Product Change Notification / JAON-04TMOL584

CCB 4539 Initial Notice: Qualification of a new lead frame design for selected products available in 8L SOIC package using 8390A die attach and palladium coated copper wire with gold flash (CuPdAu) bond wire material assembled at MMT assembly site.

CCB 4539
Pre and Post Change Summary
PCN # JAON-04TMOL584

Pre Change

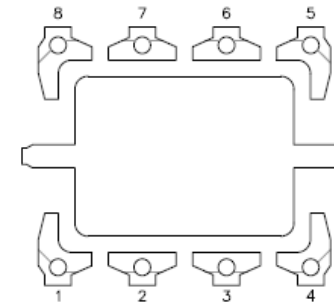
LF STRIP DENSITY: x140
LF PAD SIZE: 95x130 mils
LEAD LOCK: NO

Post Change

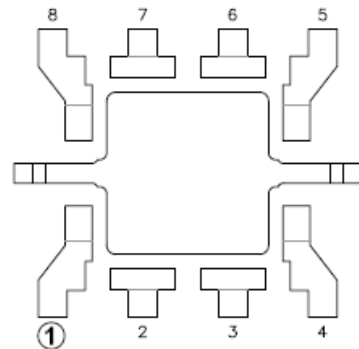
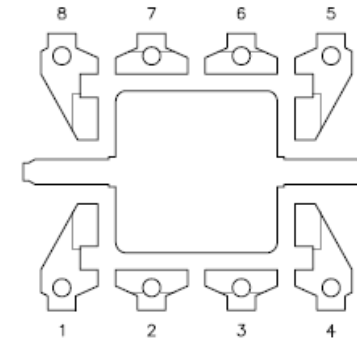
LF STRIP DENSITY: x320
LF PAD SIZE: 95x130 mils
LEAD LOCK: YES

LF STRIP DENSITY: x320
LF PAD SIZE: 90x90 mils
LEAD LOCK: YES
